Proposal

Variation of conditions 1, 2, 3, 6, 7 and 8, and removal of condition 9 of PL/2025/04414 to allow minor amendments to plot layouts and accommodate revised house types following the acquisition of the site by Bellway

PL/2026/04774

Bewley approved reserved matters

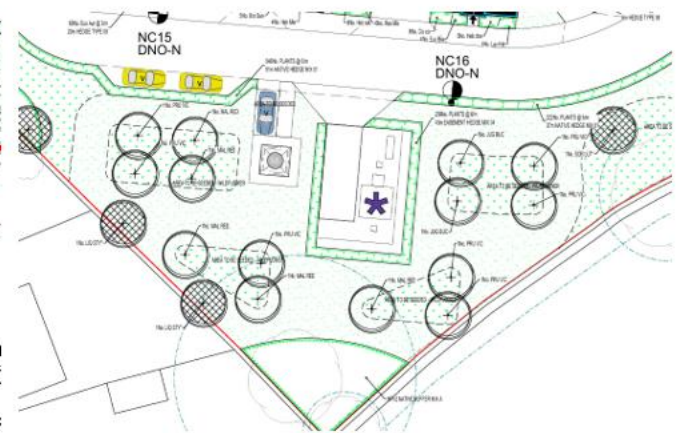
Substation moved to other side of site.
Brick building with parking
Increase of hard surfacing
Decrease of trees in community orchard

Community orchard and trees were important part of approved plans in this area adjacent to Great Parks bungalows

Approved Bewley

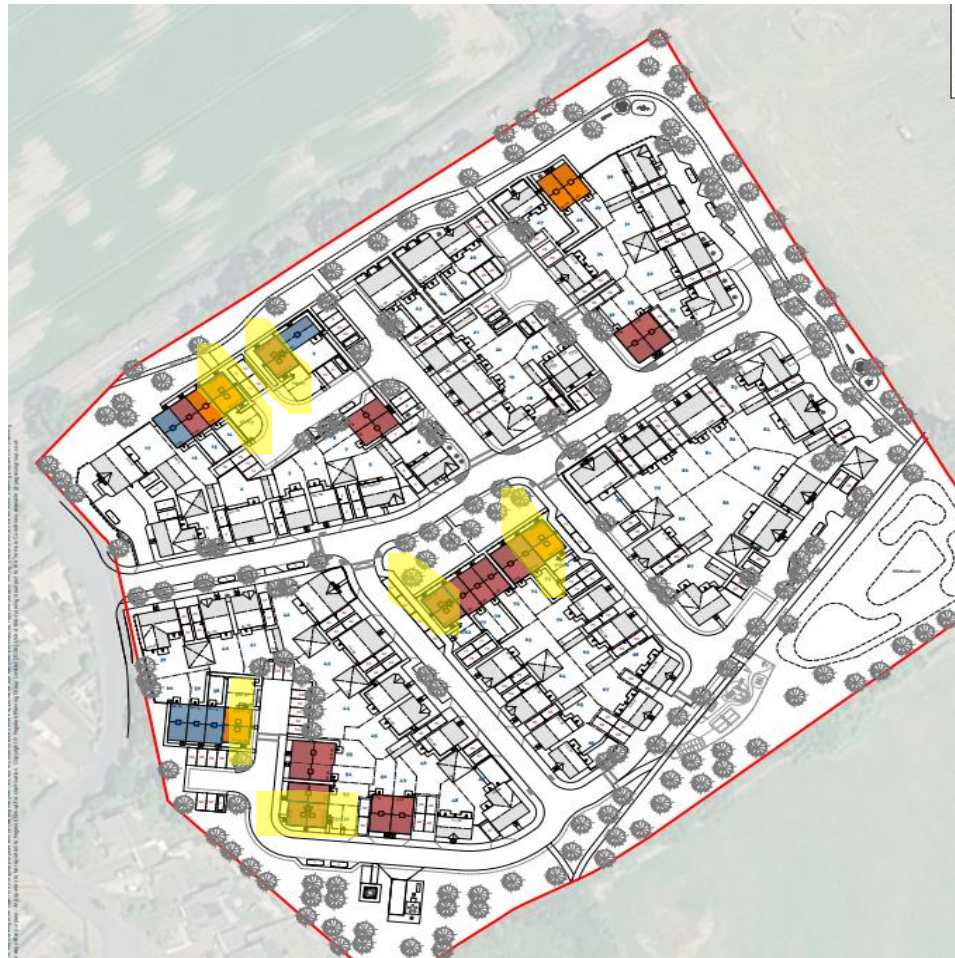
1 beds Alms Style maisonettes not substituted by Bellway. Some replaced with 2 bed houses and 8 x 1 beds relocated within the site. Architectural detail changed too.

1 beds distributed across site instead of Alms House style feature at central green.

Parking court removed at central green – 6 more parking on street and no visitor spaces.

Approved Bewley

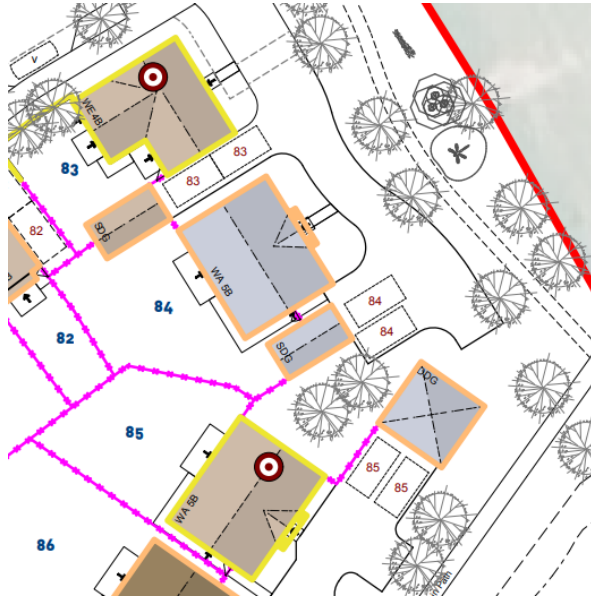
View as drive into village at eastern edge

View on central green area

PLOTS: 1, 18, 33(H), 39, 47, 83, 87(H)
PLEASE REFER TO MATERIALS PLAN FOR DETAILED SPECIFICATION
(DOOR COLOURS SHOWN)

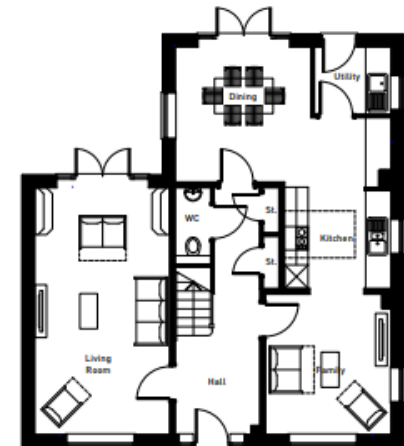
Proposal – 16 plots with chimneys.

Location of chimneys on some plots compared to floor plans raises questions.

2 blocks of 1 bed maisonettes have chimneys.
